Re: Labor Building - Window Replacement
SCO # 22-25223-01A Code: 42101 Item: 4218

Addendum No. 2

K15 NORTH ELEVATION SCALE : 1/8" = 1'-0"

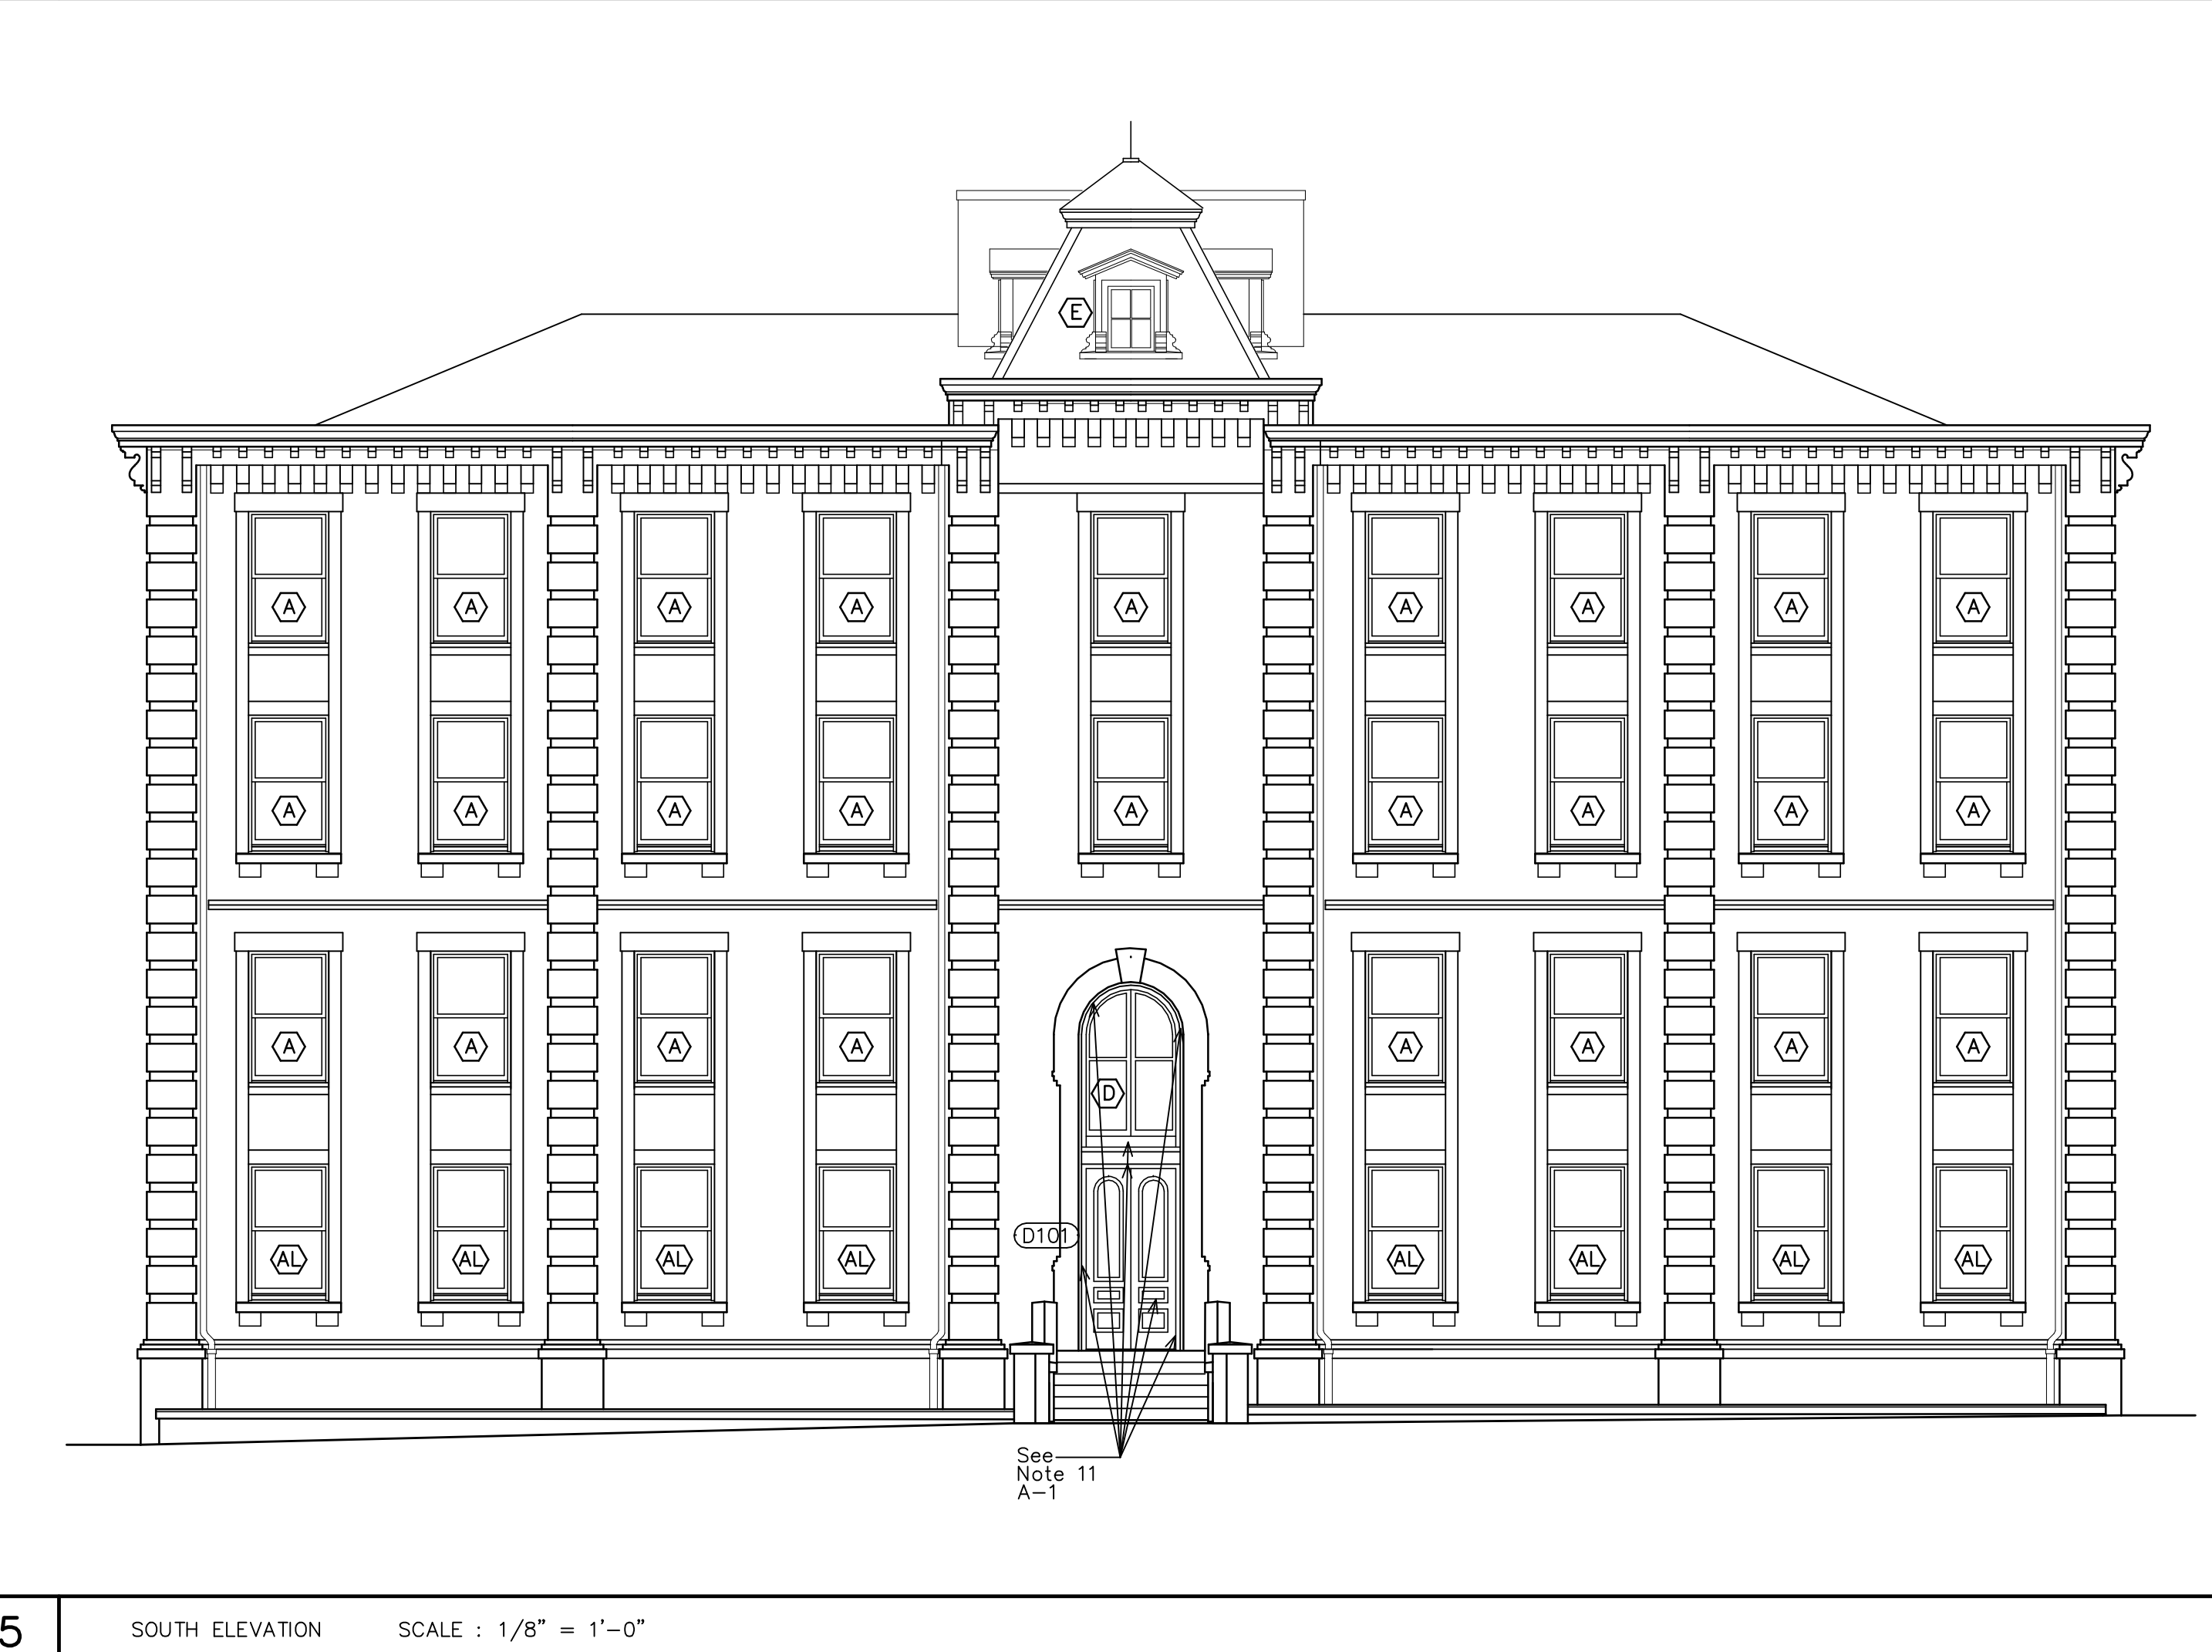
Revise K15 / Sheet A-4 North Elevation to Show Vertical Muntins at Window Types C and CL.
Reissued Revised Drawing A-4 is included.
